#### 191st session

## Proposal for 02 series of amendments to UN Regulation No. 134 (Hydrogen and Fuel Cells Vehicles)

### Submitted by the Working Party on Passive Safety \*

The text reproduced below was adopted by the Working Party on Passive Safety (GRSP) at its seventy-third session (ECE/TRANS/WP.29/GRSP/73 para. 37). It is based on ECE/TRANS/WP.29/GRSP/2023/8 as amended by GRSP-73-54. It is submitted to the World Forum for Harmonization of Vehicle Regulations (WP.29) and to the Administrative Committee (AC.1) for consideration at their November 2023 sessions

Figure 1  
**Verification test for performance durability (hydraulic)**

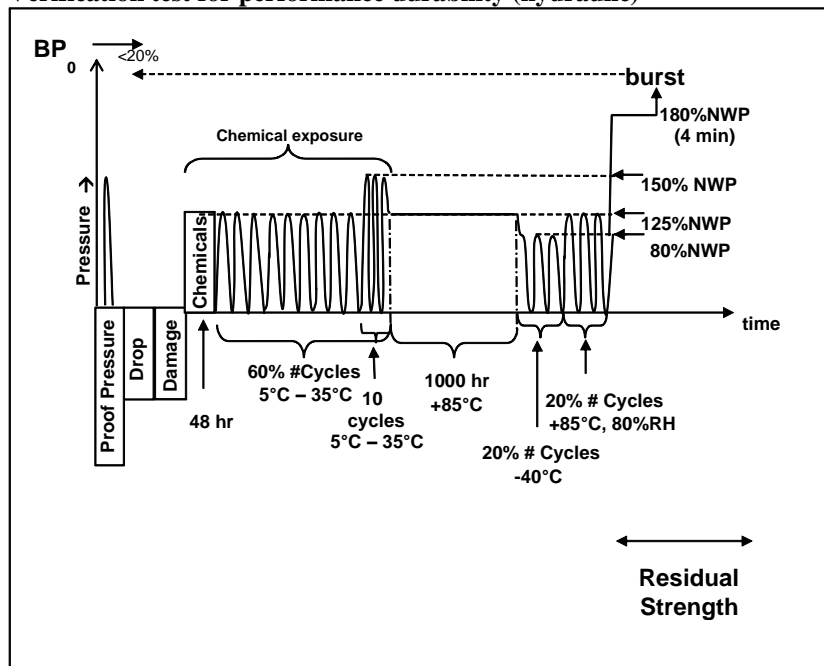
5.2. Verification tests for performance durability (Hydraulic sequential tests)

If all three pressure cycle life measurements made in paragraph 5.1.2. are greater than 11,000 cycles, or if they are all within  $\pm 25$  per cent of each other, then only one (1) container is tested in paragraph 5.2. Otherwise, three (3) containers are tested in paragraph 5.2.

Unless otherwise specified, the tests in paragraph 5.2 shall be conducted on the container equipped with its container attachments (if any) that represents the CHSS without the primary closures.

The container shall not leak during the following sequence of tests, which are applied in series to a single system and which are illustrated in Figure 1. Specifics of applicable test procedures are provided in Annex 3, paragraph 3.

Figure 2

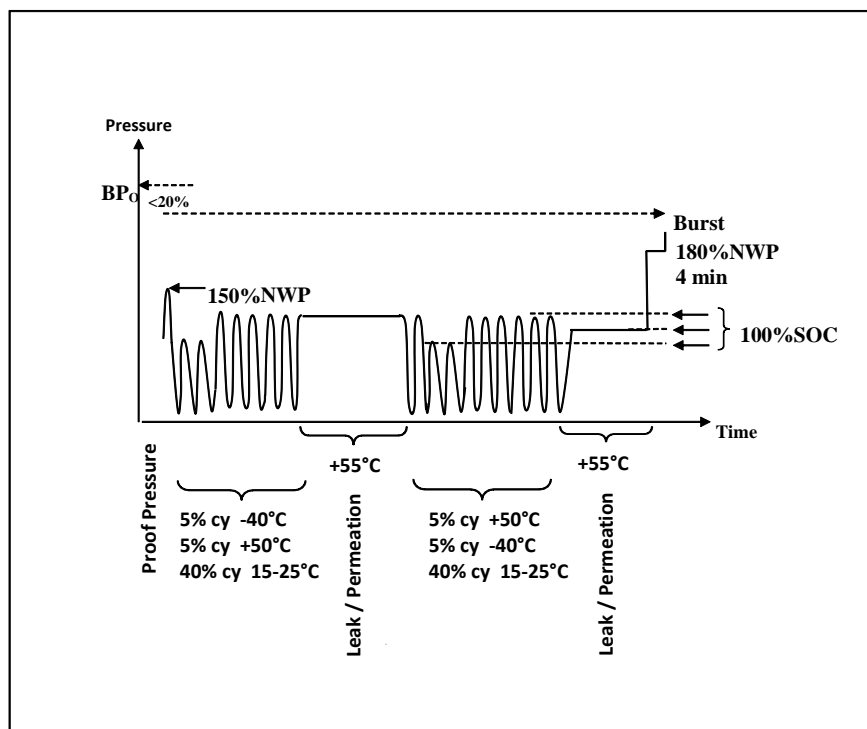
## 5.3. Verification test for expected on-road performance (Pneumatic sequential tests)

CHSS shall undergo the following sequence of tests, which are illustrated in Figure 2. Specifics of applicable test procedures for the CHSS are provided in Annex 3.

The CHSS shall not leak and the primary closure devices shall maintain functionality during the test.

Figure 2  
Surface damage flow chart

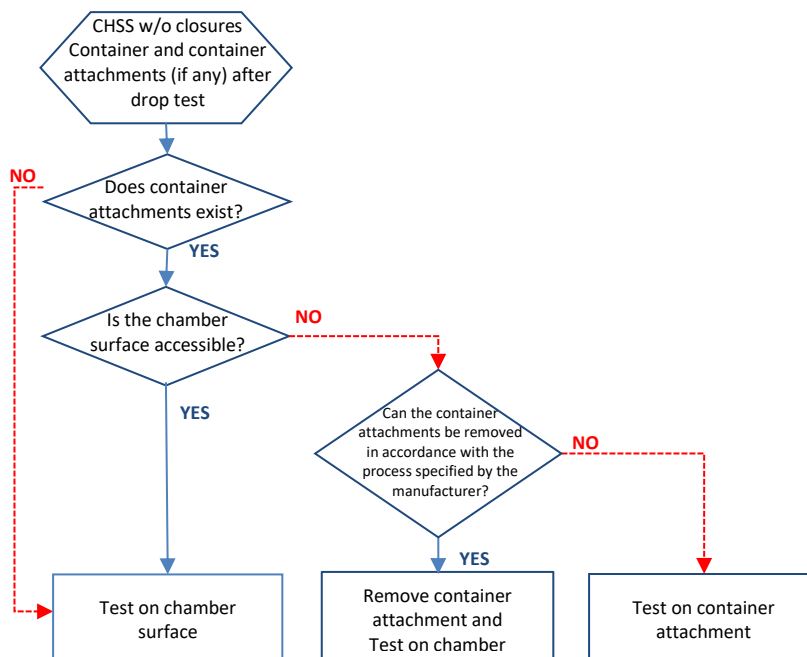
If the container attachments can be removed in accordance with the process specified by the manufacturer, then the container attachments shall be removed, and the tests shall be conducted on the surface of the pressure bearing chamber of the container.

Otherwise, the tests shall be conducted on the surface of the container attachments as indicated in Figure 2.

Figure 4  
Temperature profile of fire test

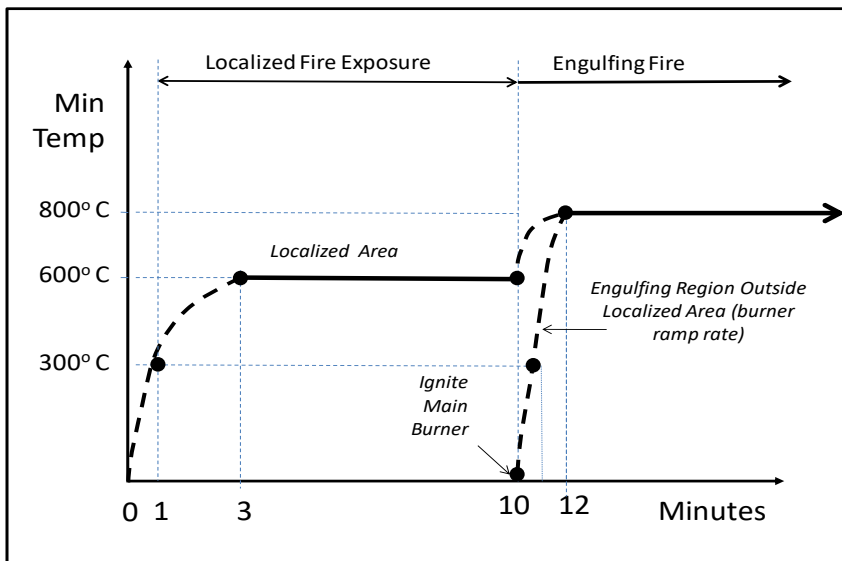
5. Test procedures for two-stage localized/engulfing fire test (paragraph 5.4. of this UN Regulation)

The test consists of two stages: a localized fire stage followed by an engulfing stage as described in Figure 4.

Figure 5  
Example of placement of instrumentation on the pre-test cylinder

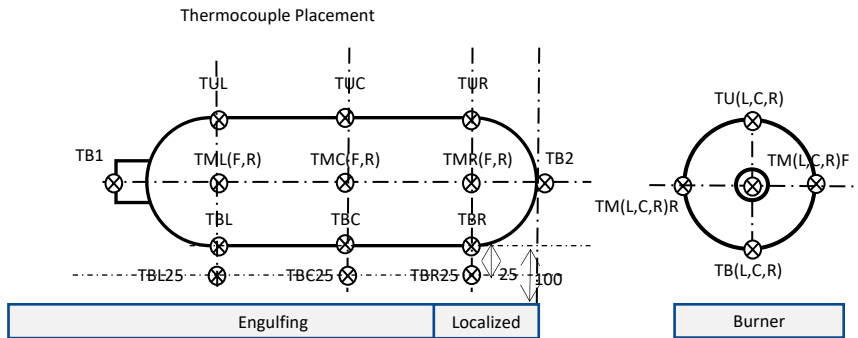
As an example of the process, Figure 5 illustrates a common situation where a container is protected by a TPRD on one end (i.e., the left end) so the localized fire zone is located on the right-end end. The surface temperatures are

measured on the top, middle, and bottom of the pre-test cylinder in three locations along the length of the cylinder. The location on the right end of the cylindrical section is centrally-located in the targeted localized zone, and the other two locations are in the centre and left ends of the targeted engulfing fire zones along the cylindrical section.

Temperature measurements on the pre-test cylinder shall be performed by  $\phi 3.2$  mm (or less) K-type sheath thermocouples that are located within a 5 mm gap from the pipe surface that are held on the surface by straps or other mechanical attachments. Temperature measurements shown in Figure 5 are defined as follows:

Figure 8  
Position the bottom of the cylindrical container relative to the burner

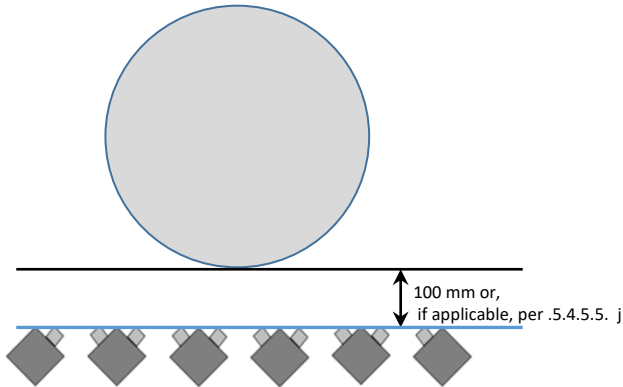
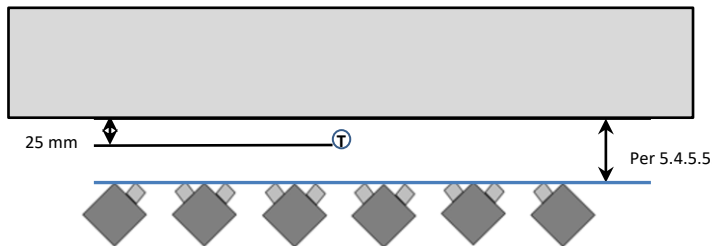
The CHSS test article shall be mounted at the same height above the burner as for the pre-test checkout in Annex 3, paragraph 5.4. and located over the burner such that nozzles on the two centrally-located manifolds (or "rails") are pointing toward the targeted region on the bottom (i.e., the lowest elevation) of the CHSS test article. See Figures 8 and 9 for examples of the mounting of cylindrical and conformable containers, respectively.
